December 10, 2008

**ADDENDUM NO. 1
TO
THE PLANS AND SPECIFICATIONS
FOR GREYSTONE PARK STAGE CONSTRUCTION PROJECT**

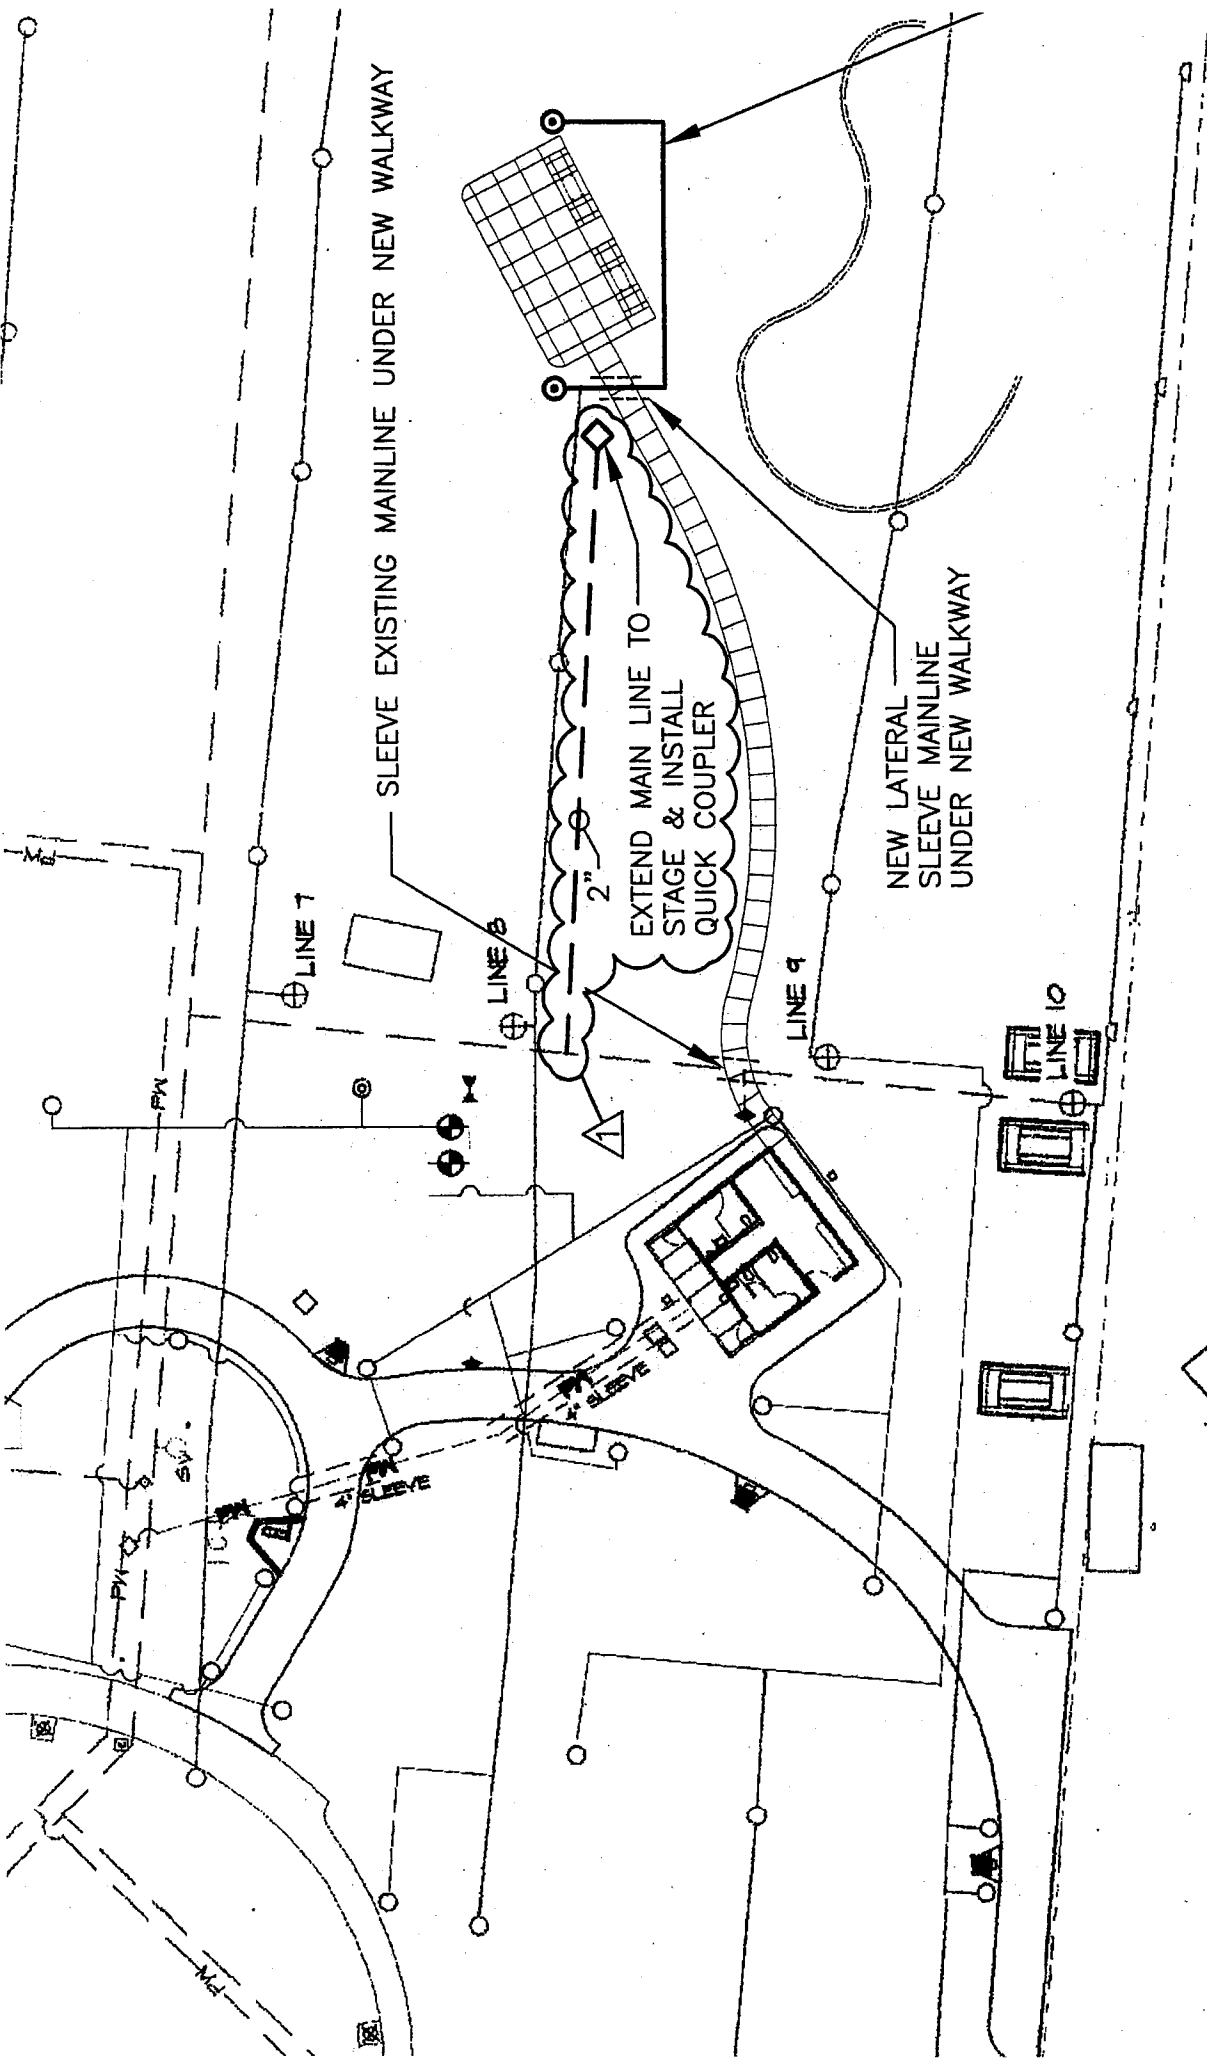
6. **DELETE** the entire Detail J.
REPLACE with the attached Detail J.
